City of Rancho Palos Verdes
Rancho Palos Verdes ADA Assessment
Facility Report with Photos

Facility ID: # 02B - City Hall Buildings

Keynote 2

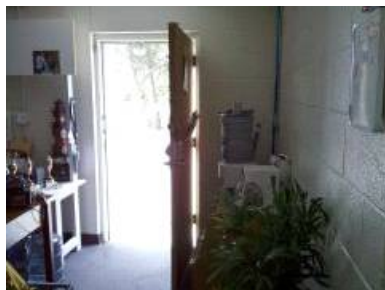
10.09A - > 1/4" Changes in Level - Threshold - Where threshold is 1/4" min.. to 1/2" max.. in height, change in level is not beveled at 1:2 or less.

064 - Threshold - Provide an accessible threshold with a height no higher than 1/2 inch and beveled with a slope no greater than 1:2.

Keynote 28

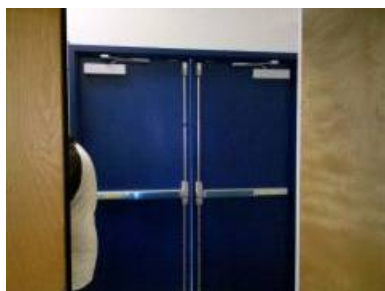
Additional Comments: Replace doors with internal locking mechanism doors.

Keynote 148

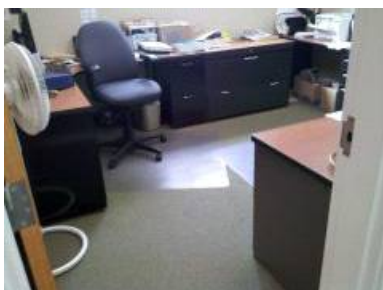
11.10B - Threshold - Height - The threshold at doorway exceeds 1/2" in height.
Existing Condition: 3/4" change in level.
